# **Staff Report**

**Re:** PLNPCM2022-00569, Accessory Dwelling Unit at 926 S 800 E

# **Conditional Use**

Timothy Vreeland, the property owner, is requesting conditional use approval for a 633-square-foot accessory dwelling unit (ADU) in conjunction with the construction of a new single-family dwelling. The existing house will be torn down as part of this project. The proposed ADU will be located in the second story of a detached garage in the rear yard accessed from the adjacent alley.

AS1.0 SITE PLANS April 12, 2023

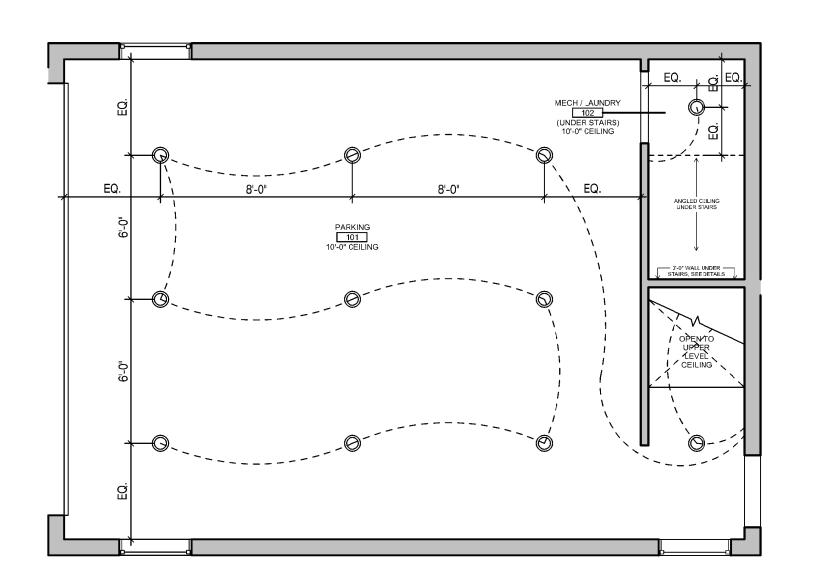
- 5. There are inadequate measurements to know whether the garage and its driveway provide the required distances for access and won't affect access to my own garage and driveway. These measurements and showing the alley in this drawing would be useful. Based on the indication of 1' setback from the west property line, the garage doesn't meet required setbacks or distance for accessing the garage and may affect my ability to access my garage.

- 7. Since it is not labelled I can't be certain, but it seems like there is an unusual amount of concrete, especially in the front yard. It appears as if the intention is to create a parking pad in the front yard, which should be denied as it is not standard in

- The two parking space requirement for the new residence is met with the new two car garage.
- The dimensions from the garage to the property line and the property line to the west side of the alley need to be provided to ensure there is adequate aisle width for accessing the garage.
- The required parking for the ADU can be meet on-street on 800 E.
- If parking for the ADU is on 800 E, a hard surfaced walkway must be provided from 800 E to the ADU.

Garage Upper Level Dimension Plan Scale: 1/4" = 1'-0"

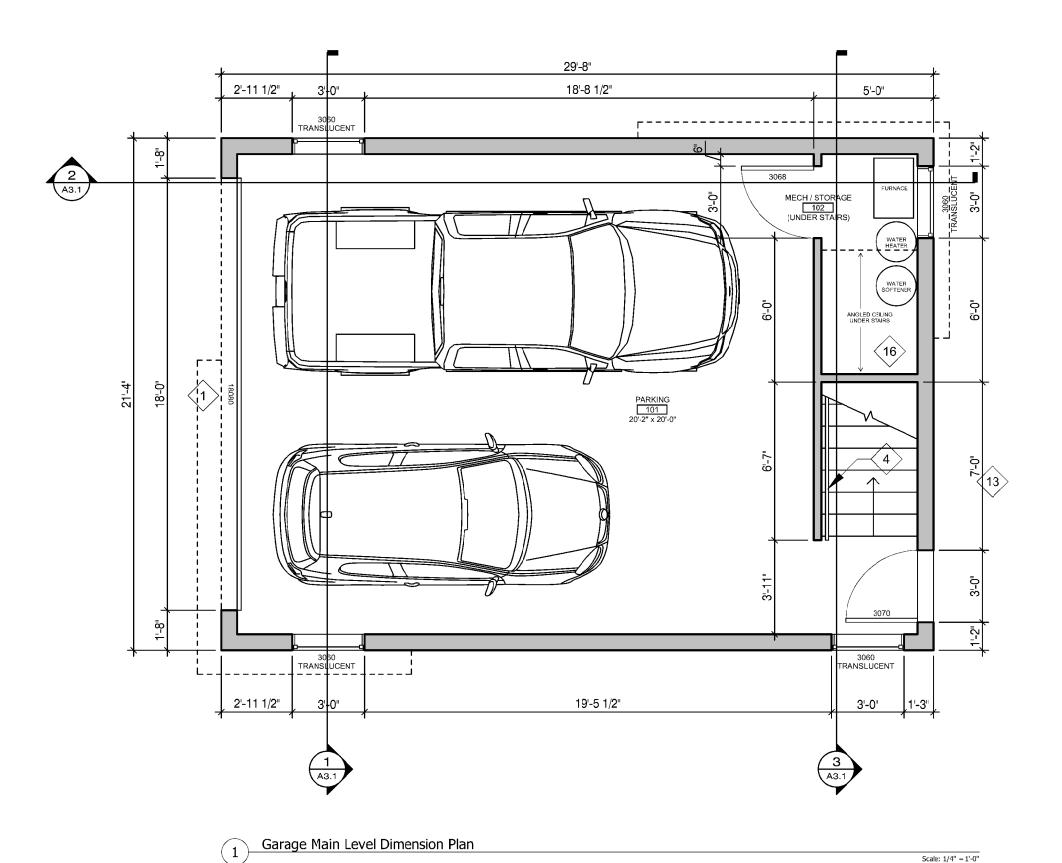
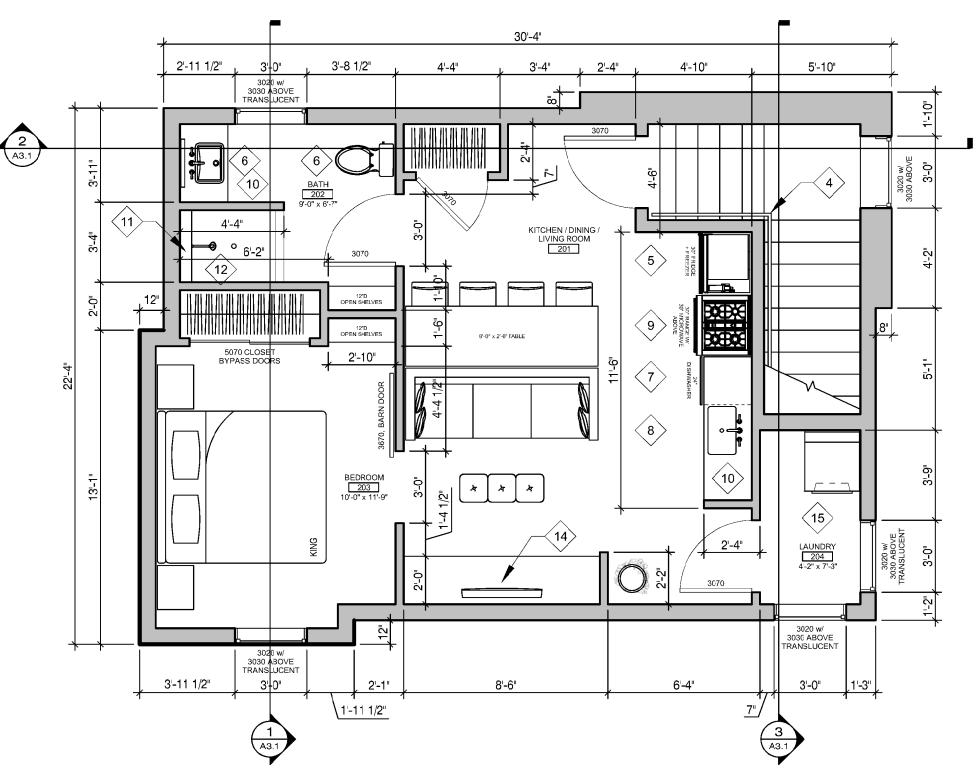
Per 21A.40.050.B2a the footprint of an accessory building shall not exceed 50% of the footprint of the principal structure or 720 square feet, whichever is less. The footprint includes anything covered by a roof. This means the covered porch and covered driveway are included in the footprint of the accessory building. According to sheet AS1.0, the footprint of the proposed principal structure is 1,399 square feet. As such, the maximum footprint of the accessory building

is 699.5 square feet. Per the dimensions provided on sheet A1.3, the footprint of the accessory building is 799.8 square feet. This exceeds the maximum footprint regulations and will need to be brought into compliance before the conditional use can be approved.

**Planning Staff Note:** These comments have been addressed and are reflected in the Plan Set found in Attachment B.

A2.2 EXTERIOR ELEVATIONS

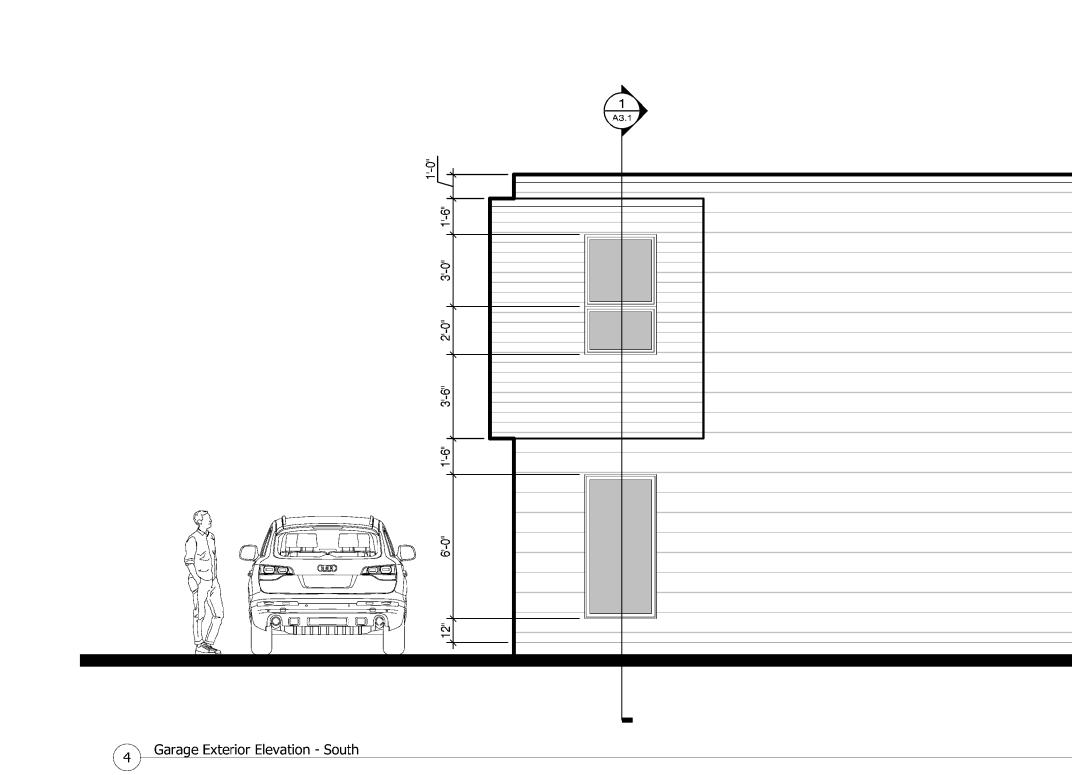
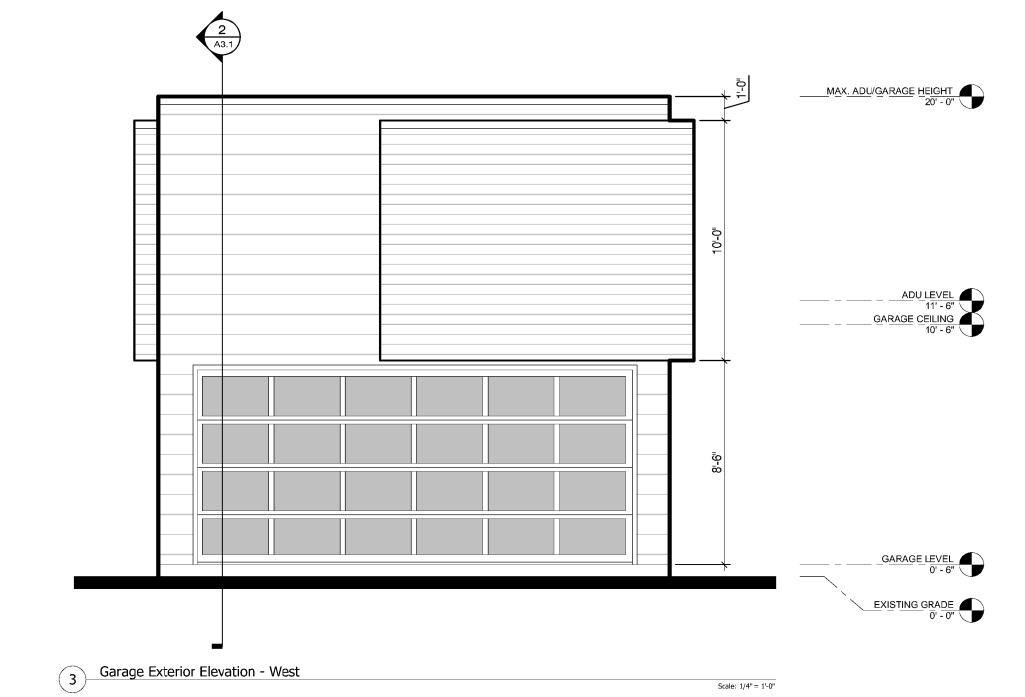
Per 21A.40.200.E3g(1) Obscured glazing is required for windows facing a side property line that are within 10' of said property line. Both the north and south elevations contain windows that are within 10' of a side property line and therefore all must use obscured glazing. Identify on the plans that all windows on the north and south facades will be obscured. The windows must comply with this standard before the conditional use can be approved.

Per 21A.40.200.E3h(2) the balcony must be setback a minimum of 10' from the side property line. Currently the balcony appears to be setback 5.5' from the south property line. This must be brought into compliance before the conditional use can be approved.
